# RENESAS TECHNICAL UPDATE

Product Category	MPU/MCU		Document No.	TN-SH7-A741A/E	Rev.	1.00
Title	Correctional specs concerning SH7261 electric characteristic tRDH1		Information Category	Technical Notification		
Applicable Product	SH7261 Group	Lot No.	Reference Document	SH7261 Group Hardware Manual (REJ09B0320-0200)		
		All

**Figure 31.12 Basic Bus Timing for External Address Space**  
(Page Read Access, External Read Data Sequential Assert Mode)

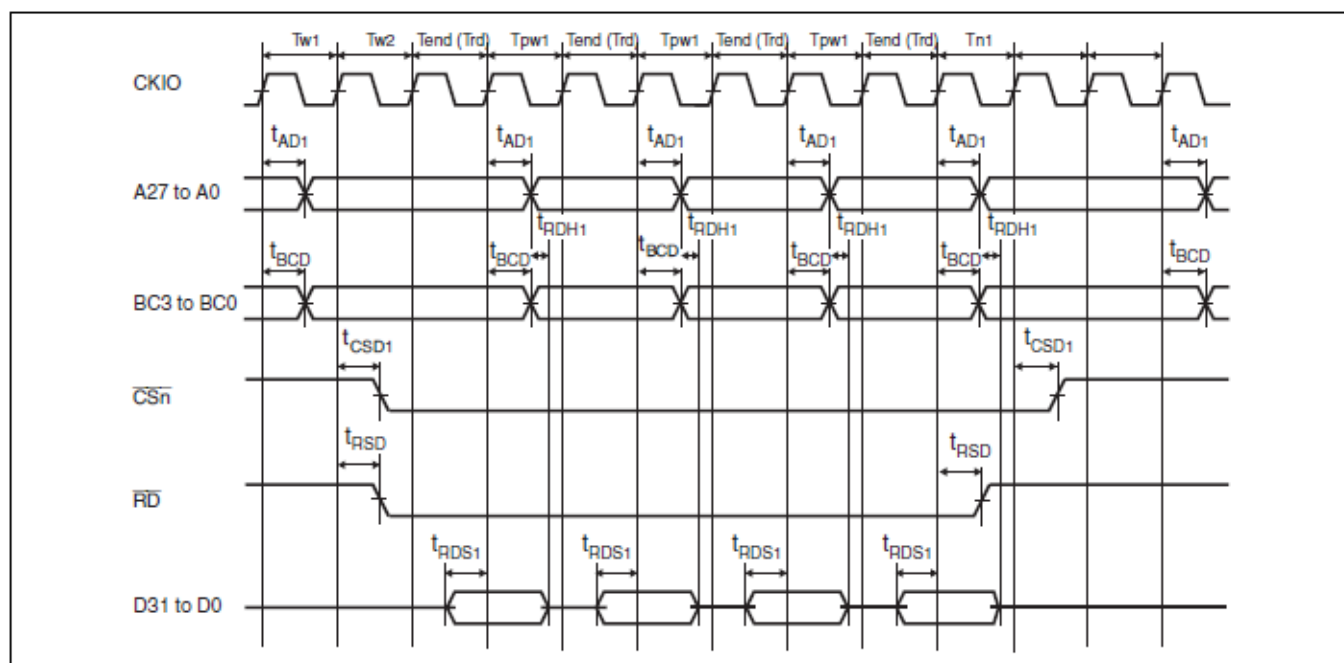
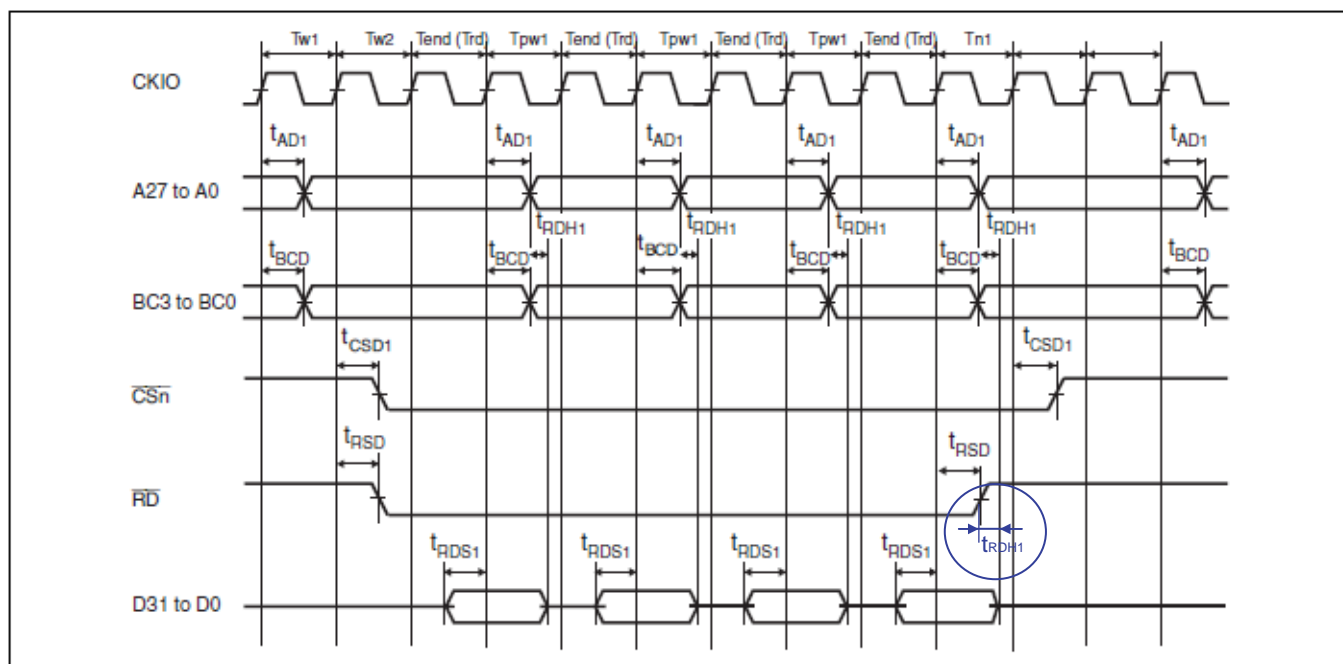
This is to notify you of the correction of the bus timing for read data hold time 1 (tRDH1) of electric characteristic of SH7261.

[The contents before manual correction]

[The contents after manual correction]
